HISTORIC PRESERVATION COMMISSION

Monday, March 2nd, 2026

**City of Avondale Estates  
Historic Preservation Commission  
COA Application Review\***

**City of Avondale Estates**  
**Historic Preservation Commission**  
**COA Application Review\***

# PROJECT SPECIFICATION

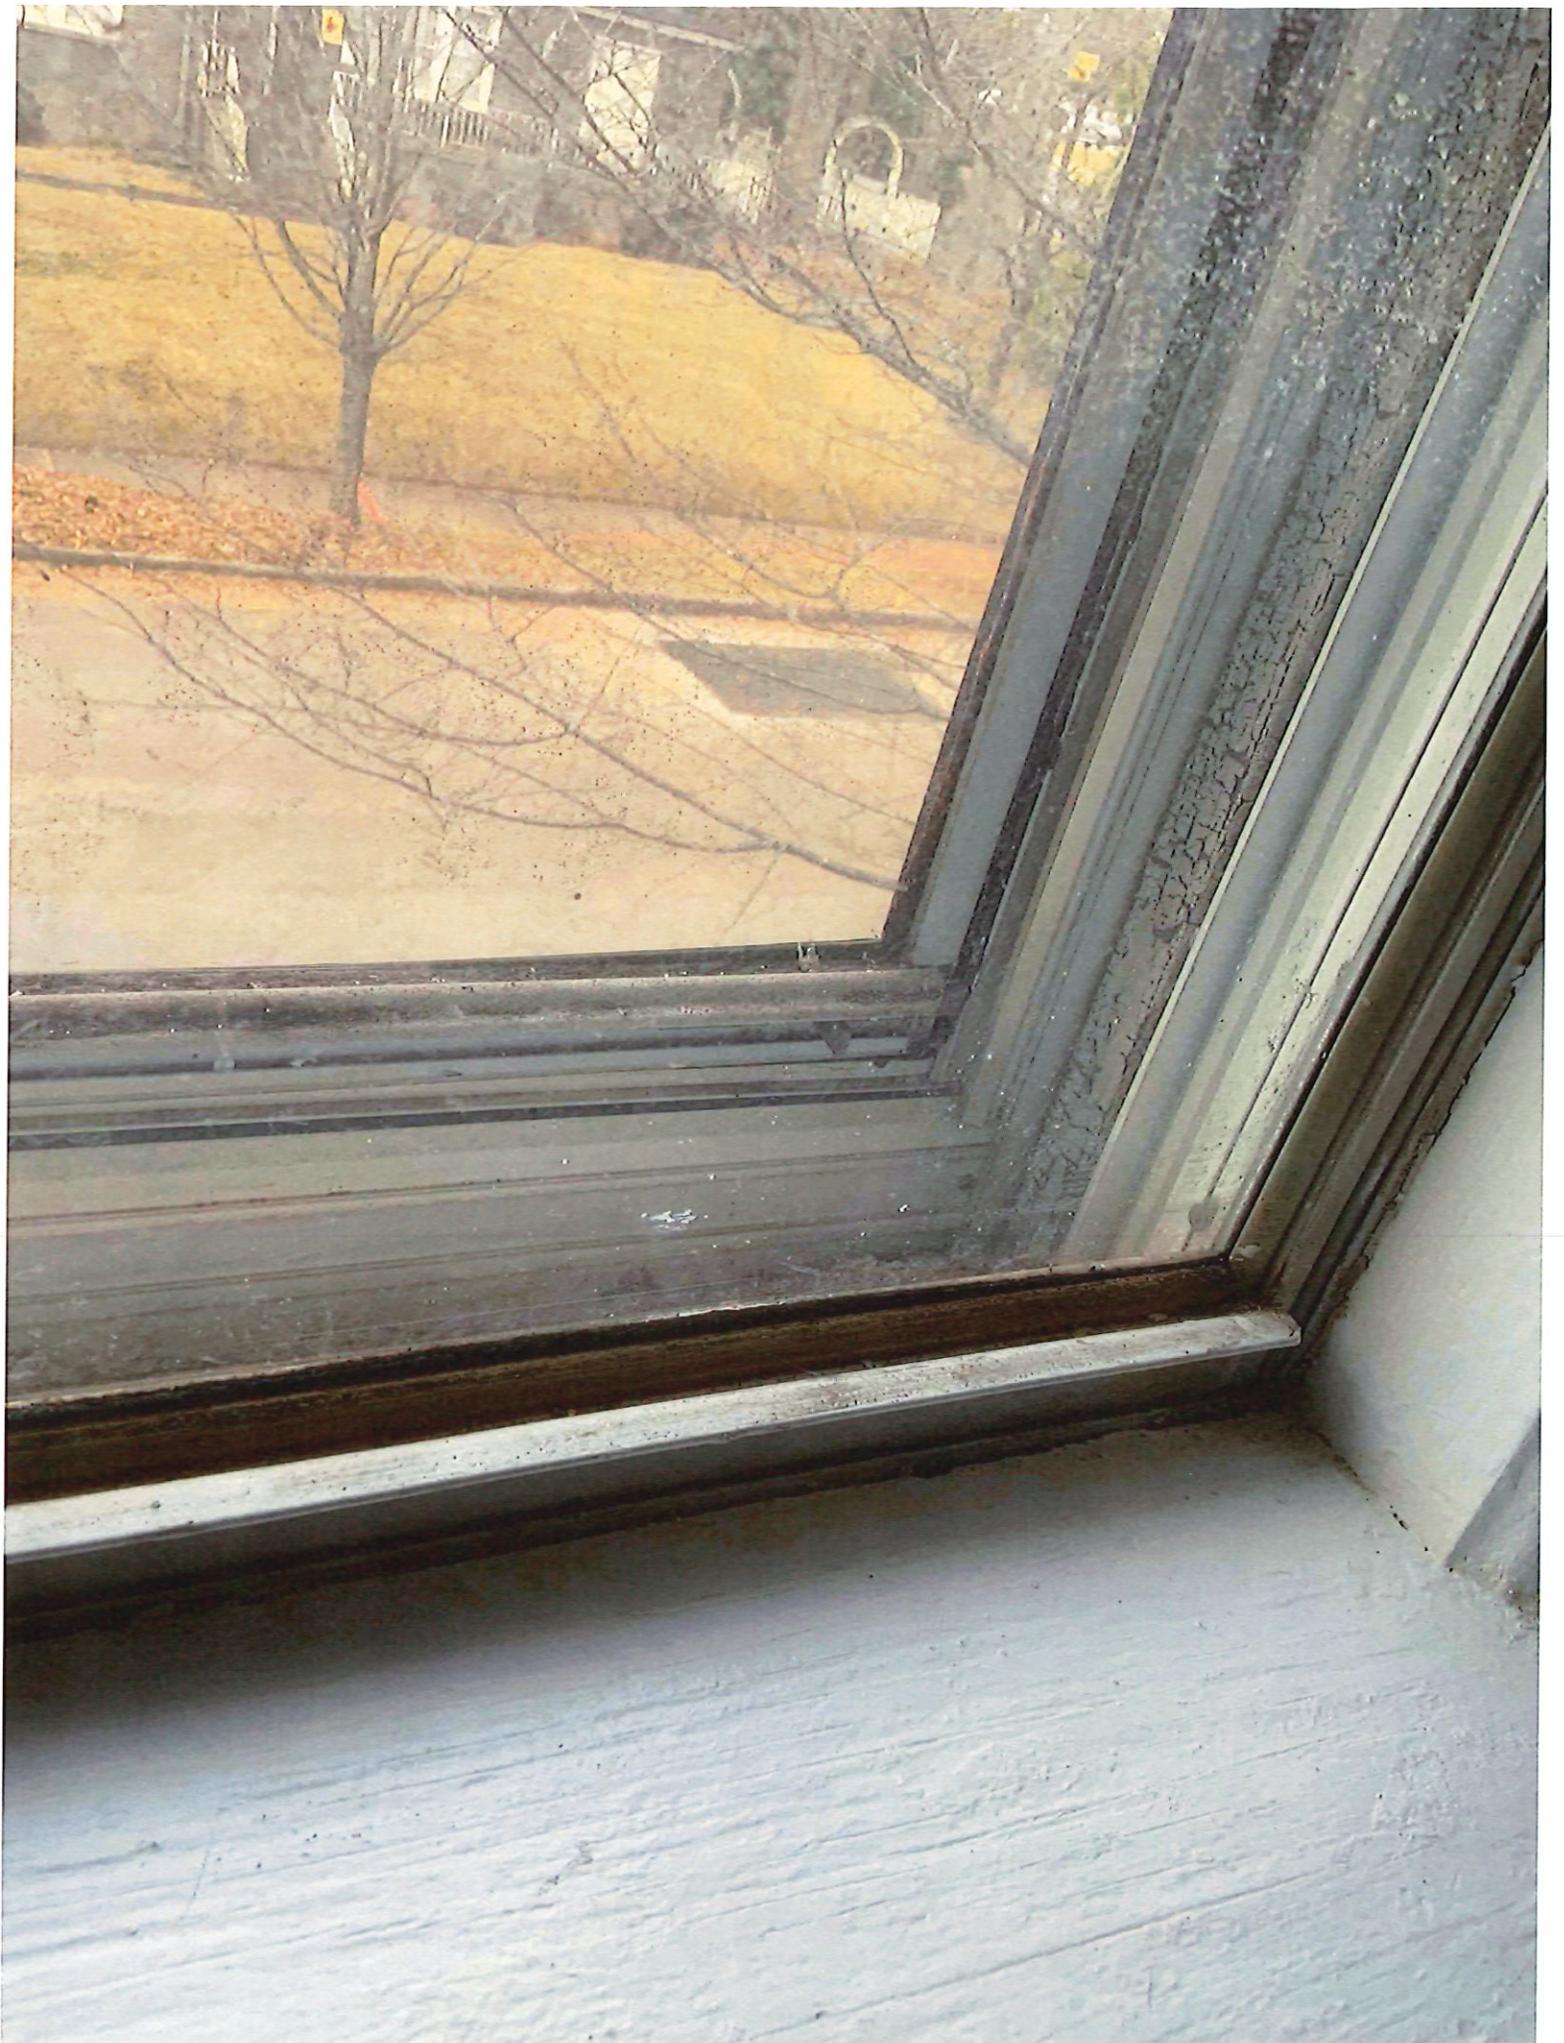
**Analysis:** The project proposes to replace five of the house's windows on the side and rear elevations. The five windows have been previously replaced and are not original to the house. These windows are 1-over-1, double-hung and appear to be a combination of metal, vinyl, and wood windows with storm windows. The proposed replacement windows will be wood with exterior cladding, 6-over-1, double-hung windows to match the appearance of the existing historic wood windows in the remainder of the house.

The windows proposed to be replaced are nonhistoric replacement windows. Therefore, the guidelines allow for them to be replaced. The proposed 6-over-1, double-hung windows may be TDLs or SDLs, and the rails, stiles, and muntin widths should match those of the house's existing historic 6-over-1 windows. The new windows' material should be wood without exterior cladding since synthetic materials are not allowed on original portions of Preservation Designation properties (see *Guidelines for Materials* below).

The *Historic District Guidelines for Materials on Preservation Designation* properties state that no new synthetic materials may be used on the original portions of Preservation Designation properties. Repair all components with the same materials. The proposed replacement windows should be wood without exterior cladding.

- Replacement windows should be wood without exterior cladding.
- Rails, stiles, and muntin widths should match those of the house's existing historic 6-over-1 windows.

**Grille Bar Widths & Pattern**

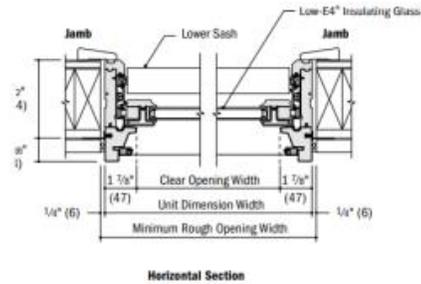
The porch's 4-over-4, double-hung wood windows are not original but may be considered historic elements. Replacement windows should be wood as proposed. The use of 4-over-4 sash instead of 6-over-1 should be considered to help maintain the porch's historic appearance.

- New enclosure materials on the porch should be wood rather than a synthetic material such as fiber-cement.
- Respect the porch's existing historic elements by using panels with a similar appearance to the beaded board panels and by considering the use of 4-over-4, double-hung, wood windows rather than 6-over-1.
- New rear entrance and basement doors should be wood rather than a synthetic material such as fiberglass.

PROPOSED  
SITE PLAN

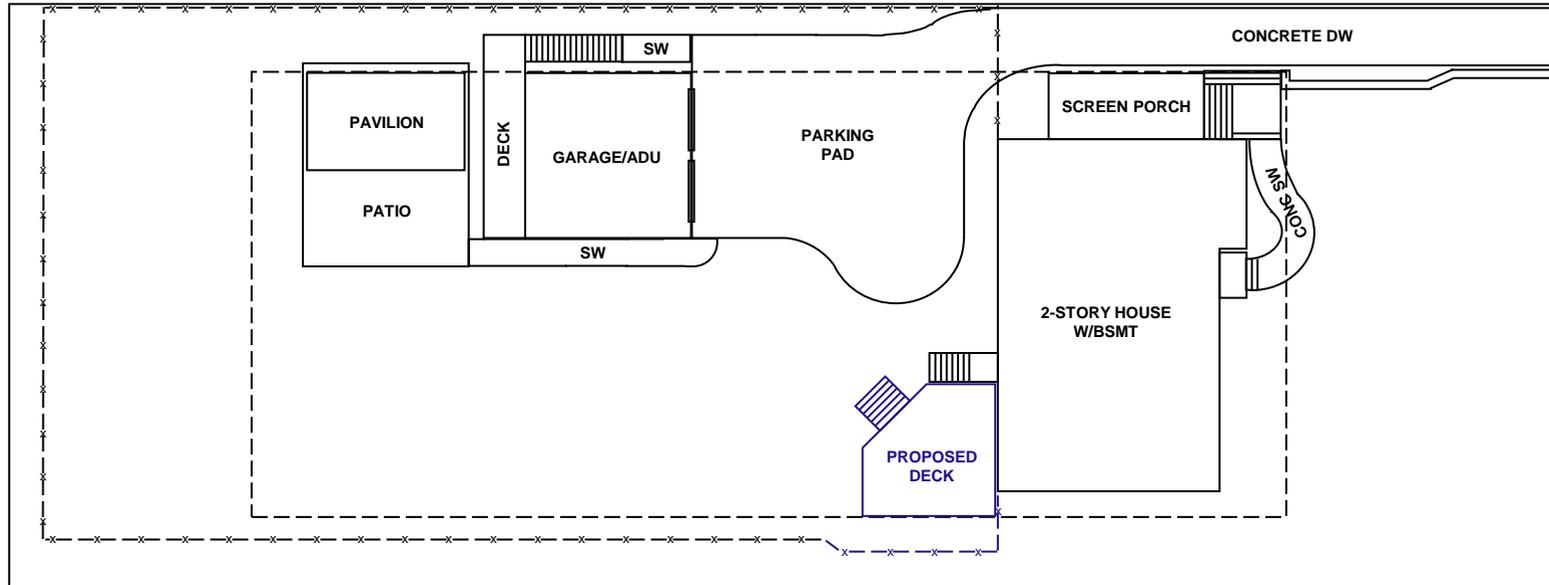
The project also proposes to (2) construct a new deck at the mudroom entrance on the house's rear elevation. The deck will measure approximately 20' by 20' and will extend approximately 3' past the house's rear corner to the 10' setback at the side property line. The deck's decking, railing, and steps will be constructed of the same composite materials as the deck on the rear of the new garage/accessory dwelling unit approved by the HPC in January 2025. The existing

masonry steps at the mudroom entrance will be removed. The existing fence along the side property line may have to be relocated slightly to accommodate the deck's extension past the house's rear corner.

The addition of a new deck is allowed on the house's rear elevation (see *Guidelines for Materials* below). Removal of the masonry steps is also allowed due to their location at the rear elevation. The additional 400 SF of the new deck minus the rear steps and concrete landing brings the total lot coverage to 34.6%.
